Name: Morné de Jager
Cell: 082 565 4059
E-mail: morne@menco.co.za
Date: 19 March 2019
Ref: Gunstfontein WEF change

**SPECIALIST STUDY: NOISE IMPACT ASSESSMENT: PROPOSED GUNSTFONTEIN WIND ENERGY FACILITY:
CHANGE OF WIND TURBINE LAYOUT**

Figure 1: New locations of wind turbines compared with old layout.

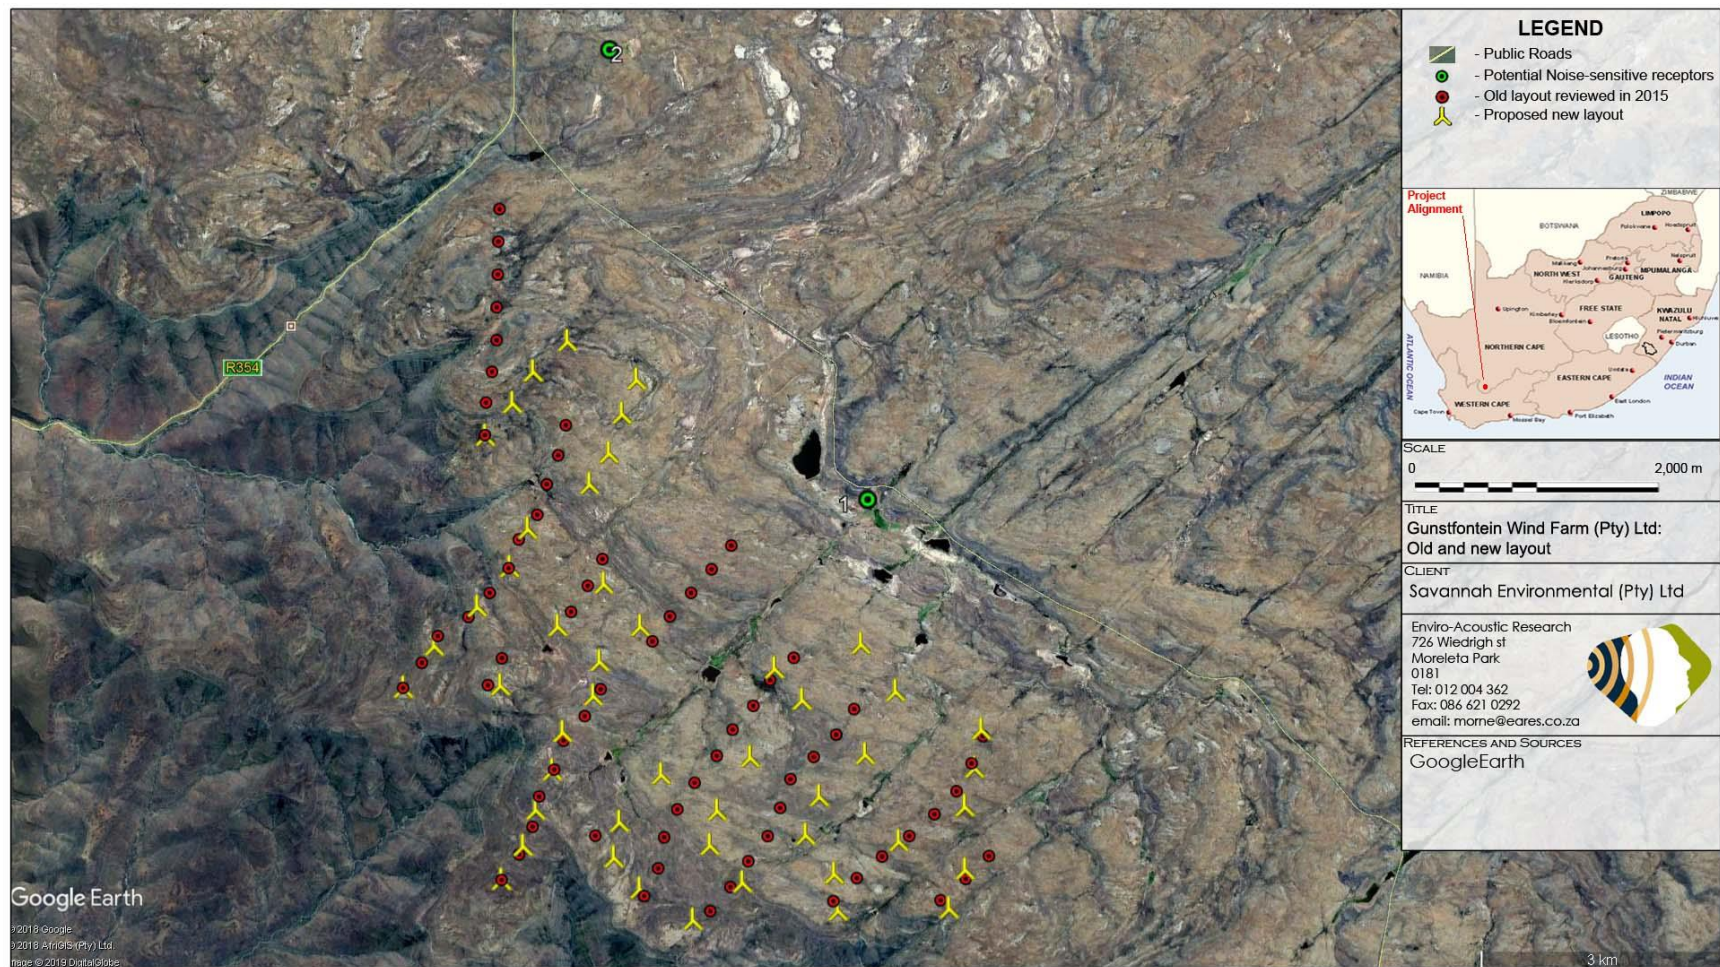
The developer of the Gunstfontein Wind Farm has since optimized the layout of the wind farm, designing the wind turbines at optimal locations (see **Figure 1**). The change however does not move any wind turbines closer than 1,000 m from any potential NSDs, with the closest wind turbine located more than 1,700 m from the closest NSD. Considering the location of the wind turbines and the potential noise impact, it is my opinion that the change will not increase the significance of the noise impact.

A full noise impact assessment with new modeling will not be required and the recommendations as contained in the previous document will still be valid. This recommendation is based on the outcome of the report which indicated that the extent of the potential impact is limited to 1, 000m from the closest wind turbines (Section 8.3, pg. 85). The impacts, the significance, findings and the recommendations of the noise report (report SE-GWF/ENIA/201512-Rev 0) will remain the same, and it will not be required to do any additional or other acoustic studies for the proposed changes.
